Re: Sunol Tree Gas Station: 3004 Andrade Road, Sunol
Water Treatment System

RE: Water Treatment System at 3000 Andrade Rd.

From: Pat Hoban [pat@weber-hayes.com]
Sent: Monday, September 15, 2003 12:56 PM
To: Drogos, Donna, Env. Health
Cc: WHA-Joe Hayes; Jeff Lawson-SVLG; Helen Hayes-Roy Tovani
Subject: T-Bear Ranch Carbon Filtration of MTBE

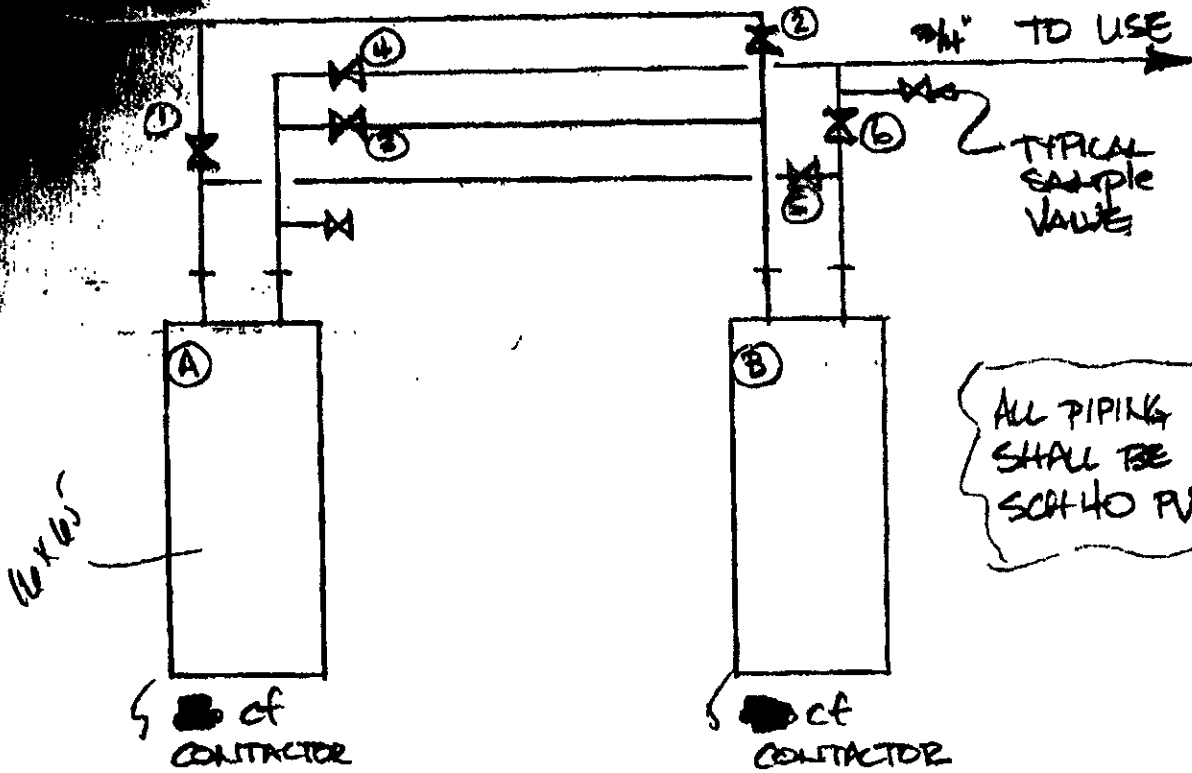
Thank you for the Culligan drawing. I am assuming that 1) each vessel will contain at least 5 cubic feet of carbon (> or = 145 lbs), and 2) the system is designed to have the retention time appropriate for removing the site-specific concentrations of MTBE.

Pat,
I believe your assumptions are correct. But you can call Stuart Dennis at Culligan if you have any questions, I am in a heavy deposition schedule at the moment. We are just waiting for the county's approval. Thx
